DVT Schematic & Layout Changing Request

Organization
R&D Lab. 2

Issued Date
2020.10.22

SoC Board

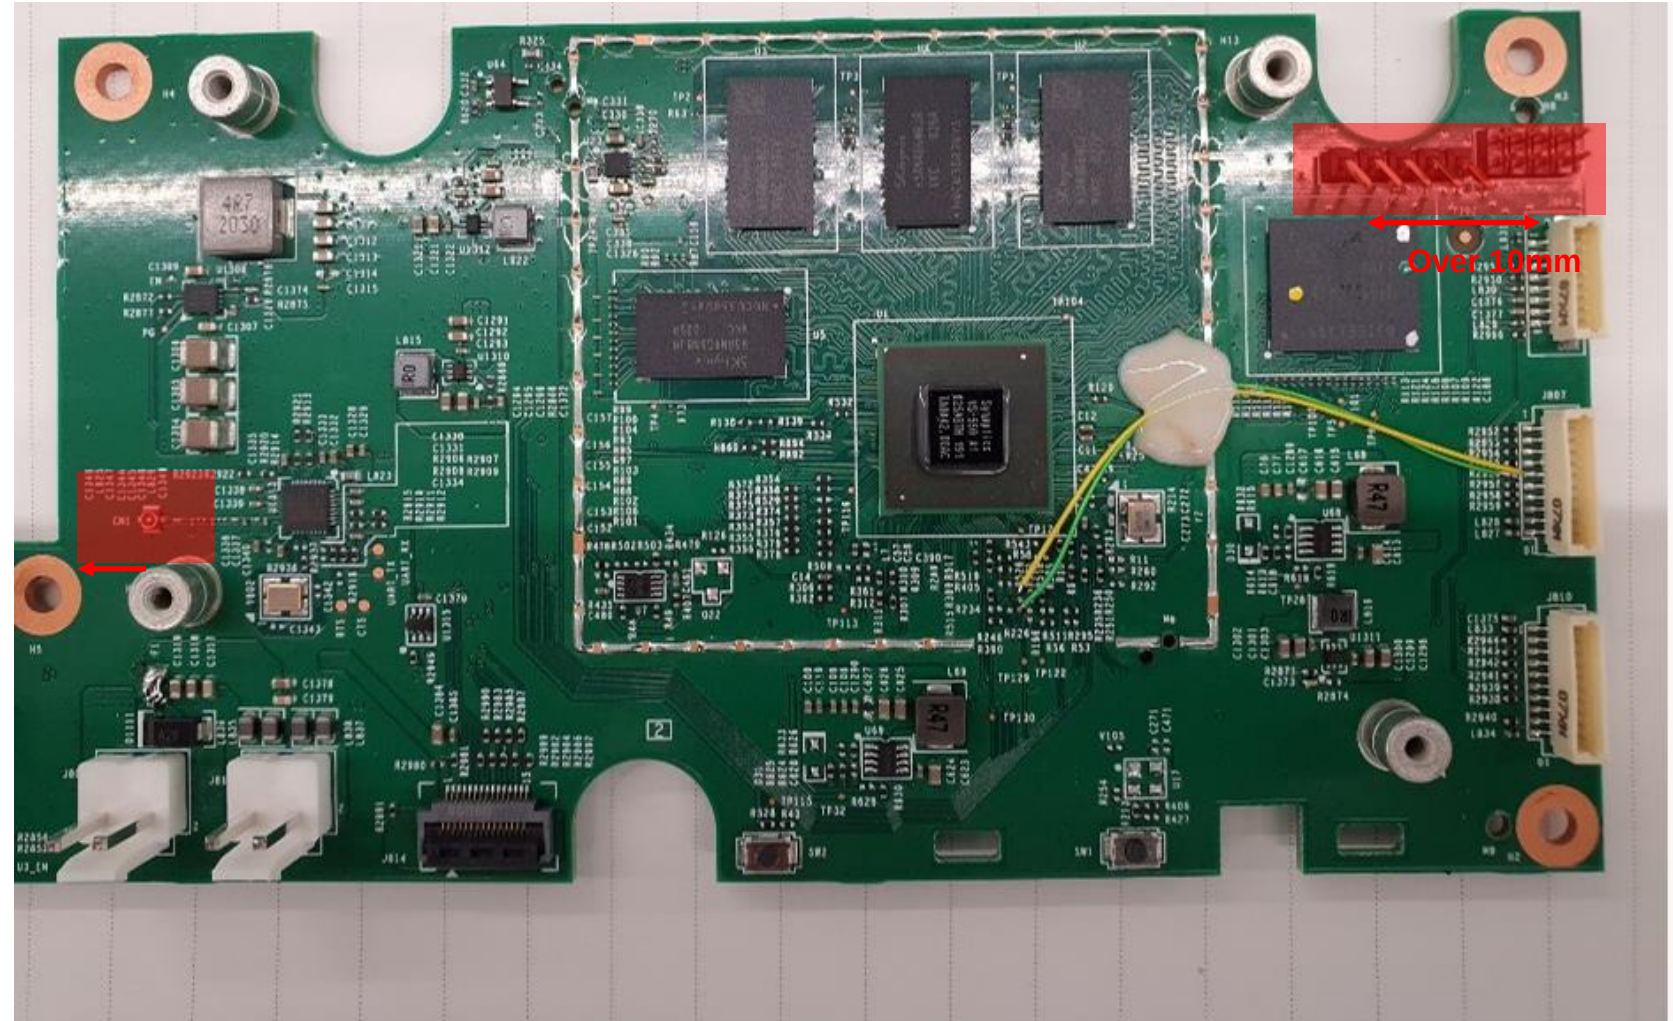
- **Add HW revision resistors(2 GPIO and pull-up/down resistors)**
- **Add circuit(components) for reduce DDR power noise(Synaptics recommend)**
- **Modify HDMI 4K 60frame**
- **Modify BT interface and add USB HUB**
- **Modify EVT rework points**
- **Add FET at 24V power line for reduce standby power consumption**

- **J4 and J6 distance : over 10mm**
 - Connector distance should be over 10mm.
- **CN1(BT connector)**
 - CN1 should be move left

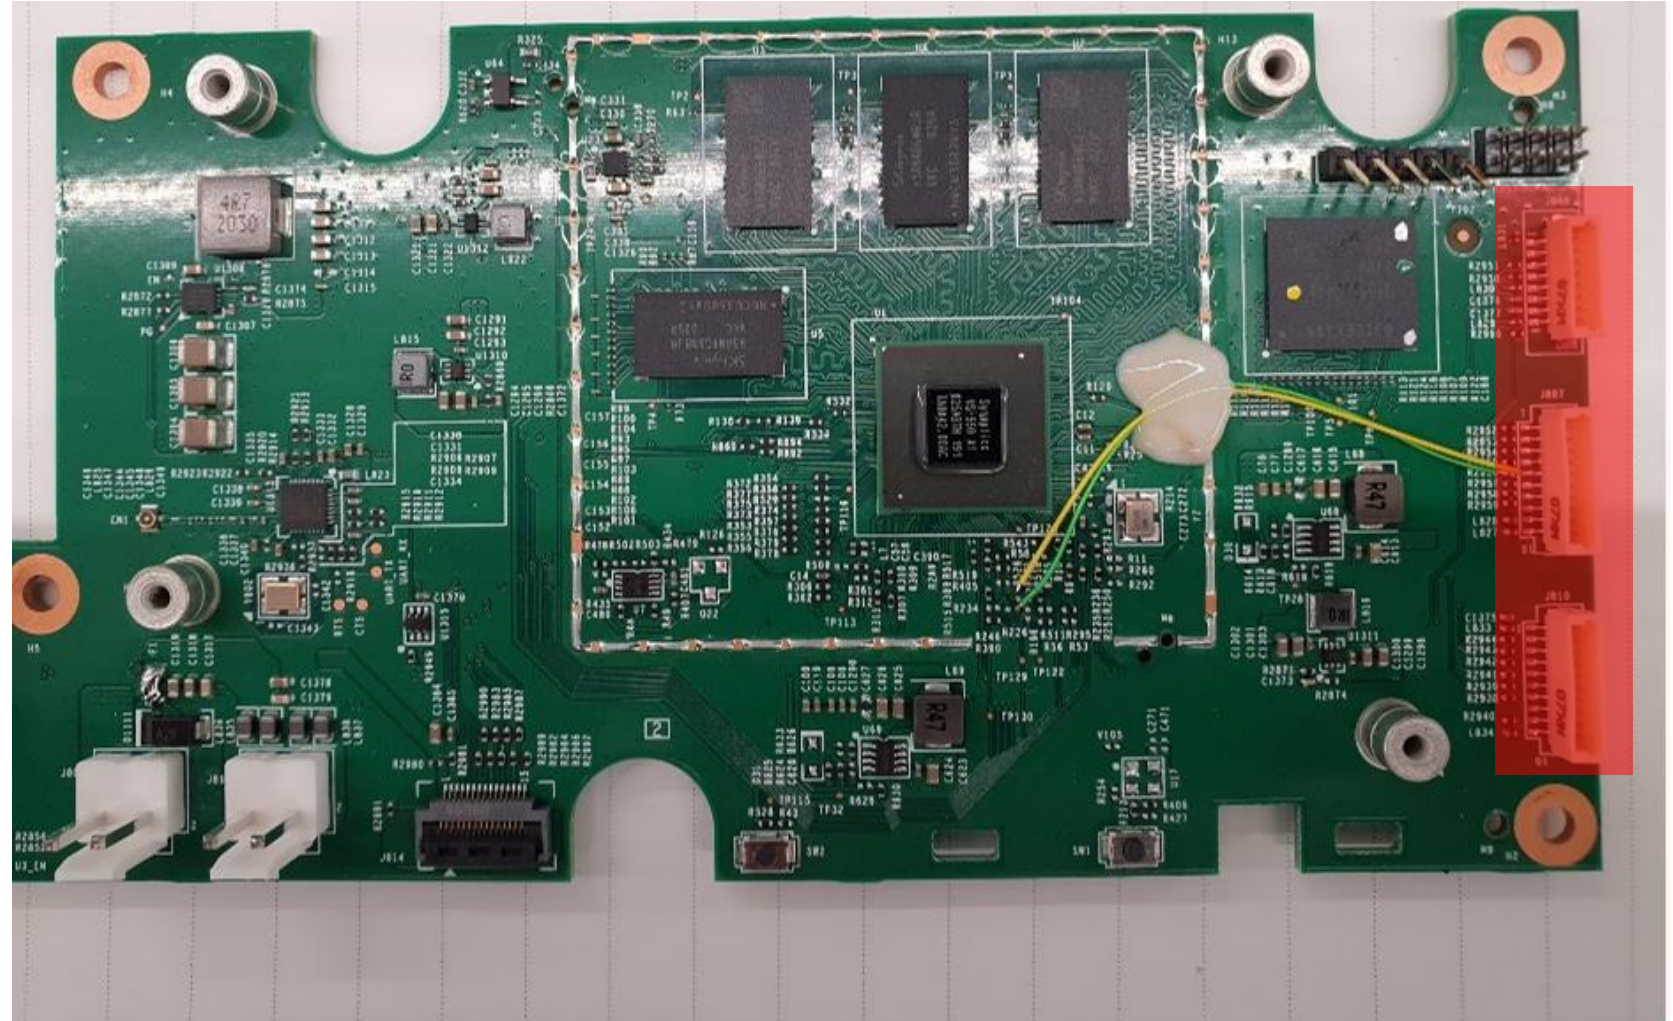
- J807, J808, J810 : Check possibility of change to FFC connectors?

Amp Board

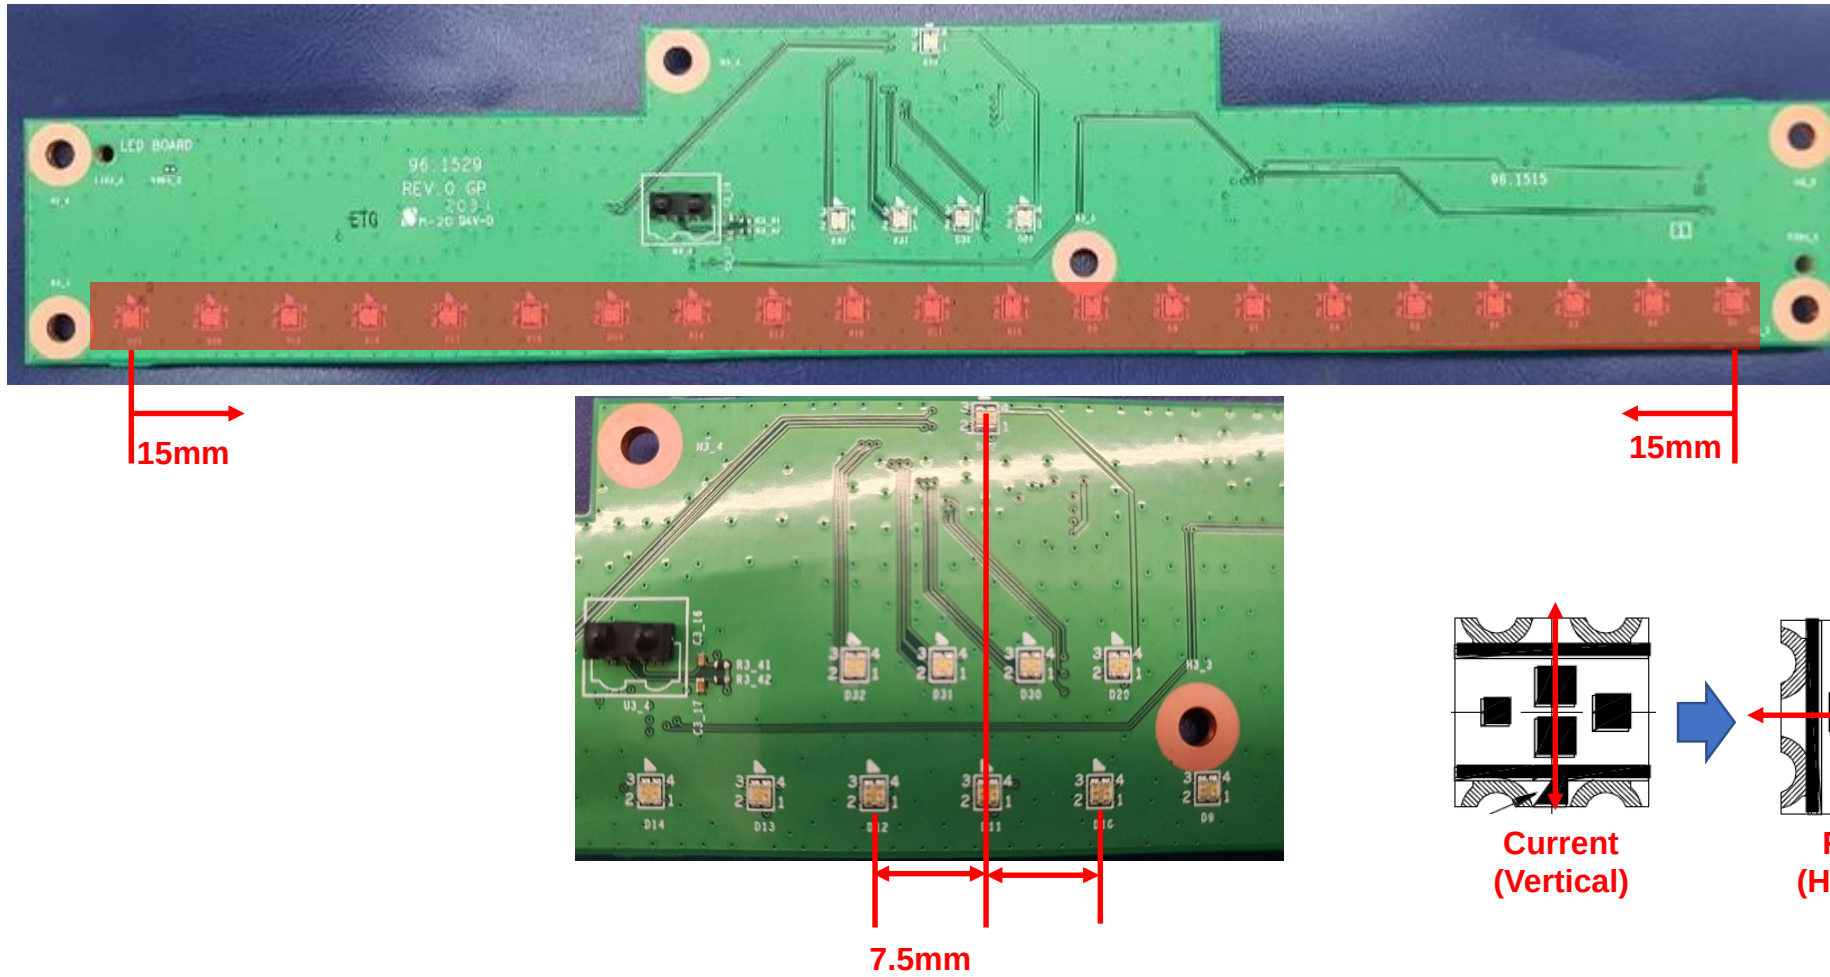
- **Connectors for Speaker**
 - J802, J803, J804: Add to Silk Speaker name(Woofer/Left/Right)
- **Connectors moving from Top to Bottom layer**
 - J802, J803, J804, J813: Location change Top to Bottom side to easy assembly
- **J802 4P connector need to divided to 2 x 2P Connectors**
 - For Harness assembly

LED Board

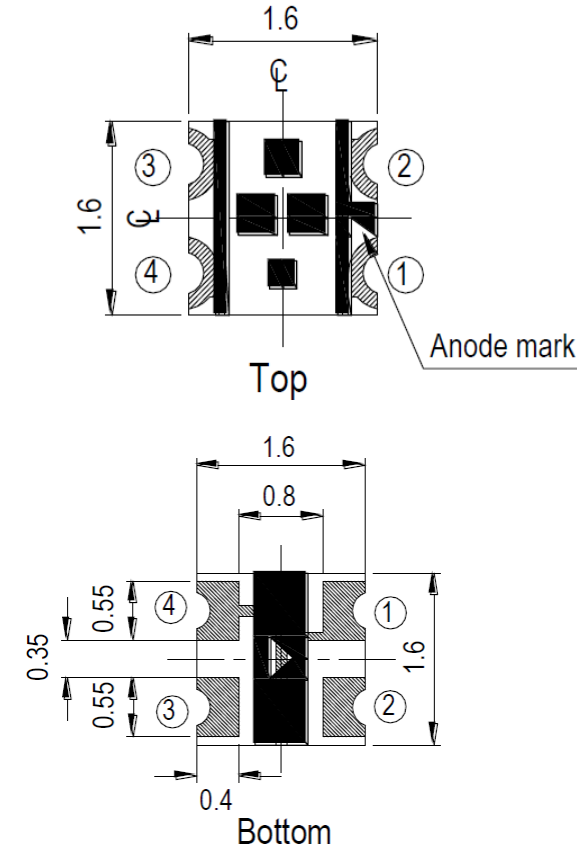
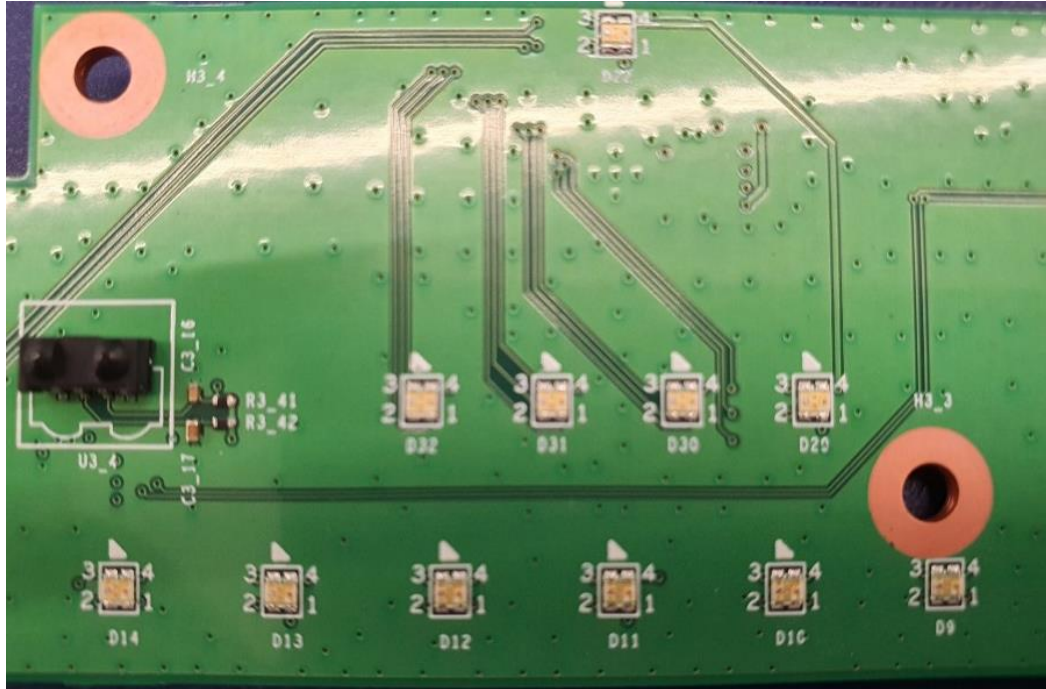
- LED distance from 9mm to 7.5mm(D1~D21) and Horizontal direction

- D1~D21: Distance(9mm → 7.5mm)
- D1~D21: Direction(Vertical → Horizontal)

- LED Pin silk need to be changed
 - Current silk referred from bottom view(change to top view)

BT Antenna placement

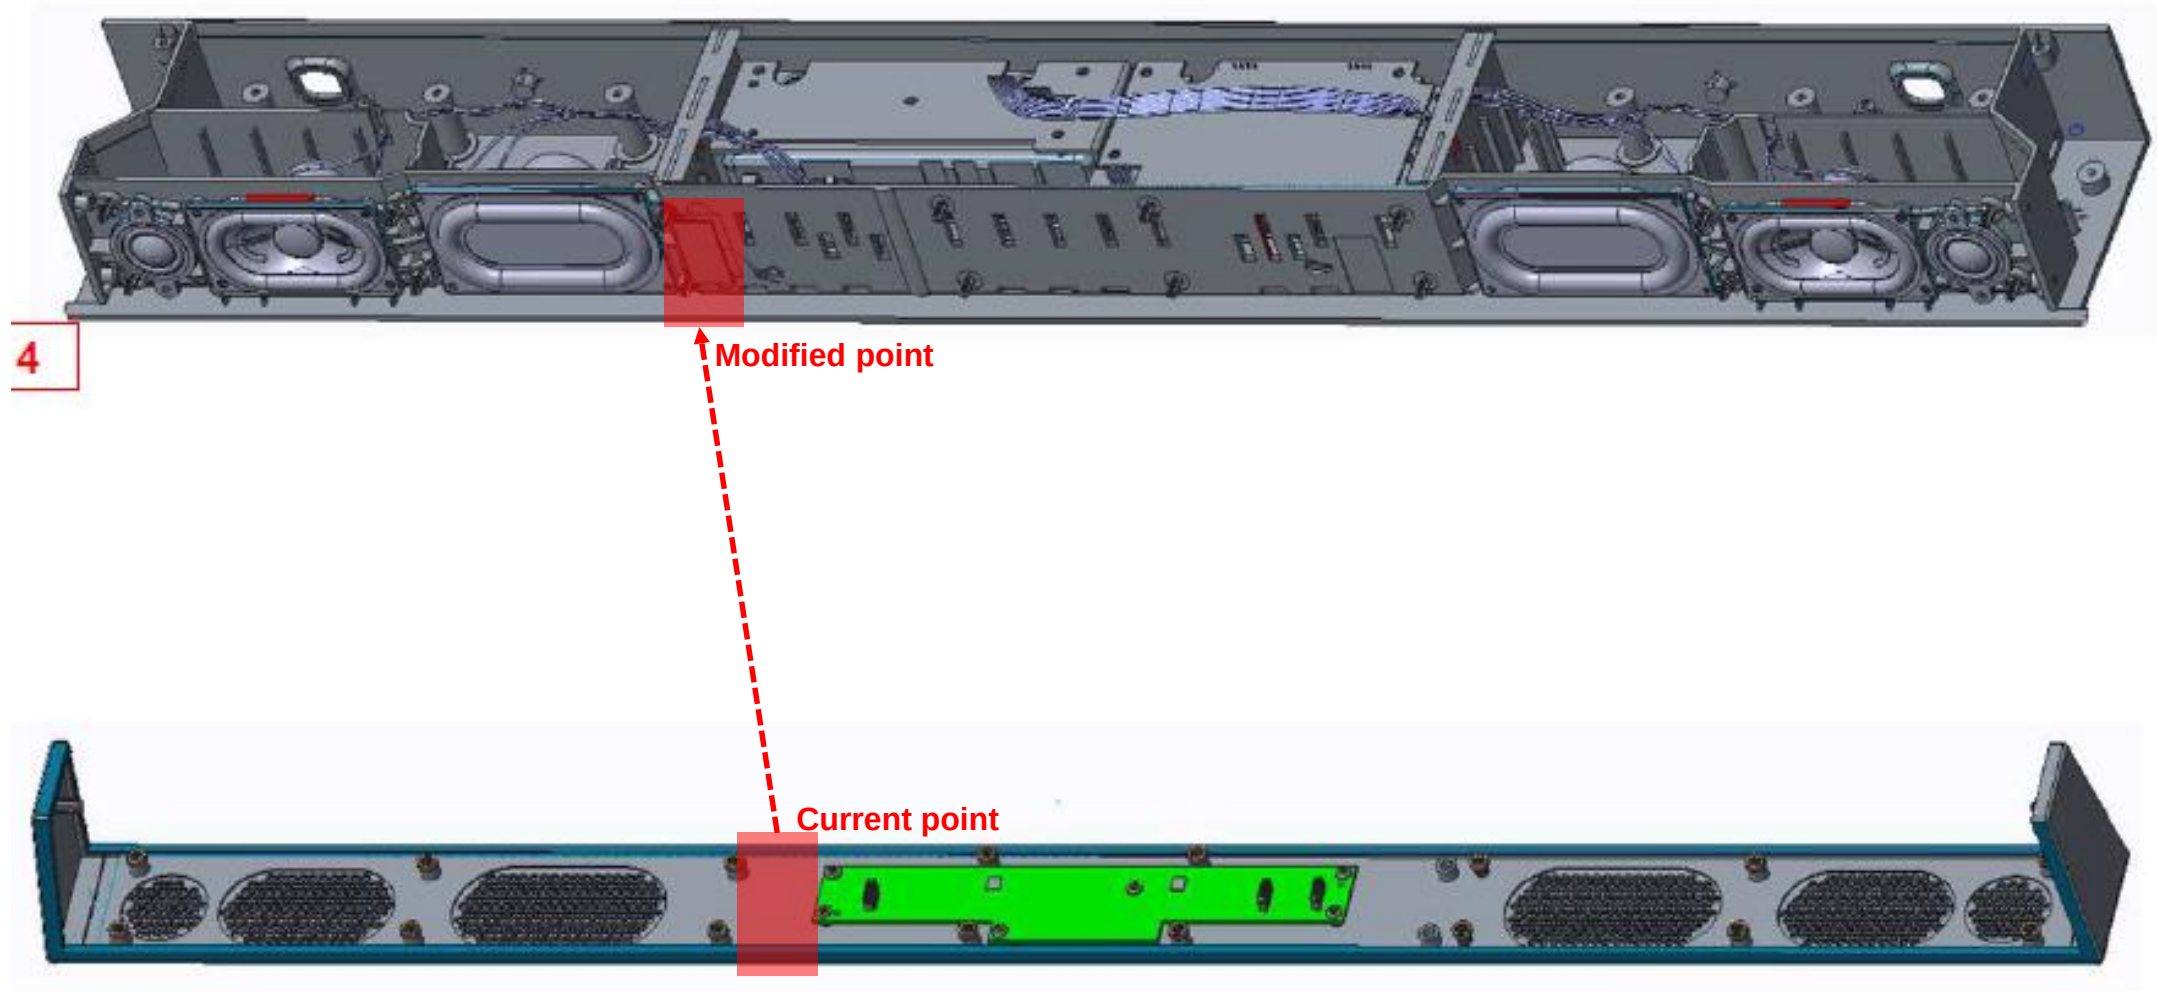
- **BT Antenna fixed point need to Bottom case**

- Current: Front panel
- Next: Bottom case(front)
- Reason: To easy assembly
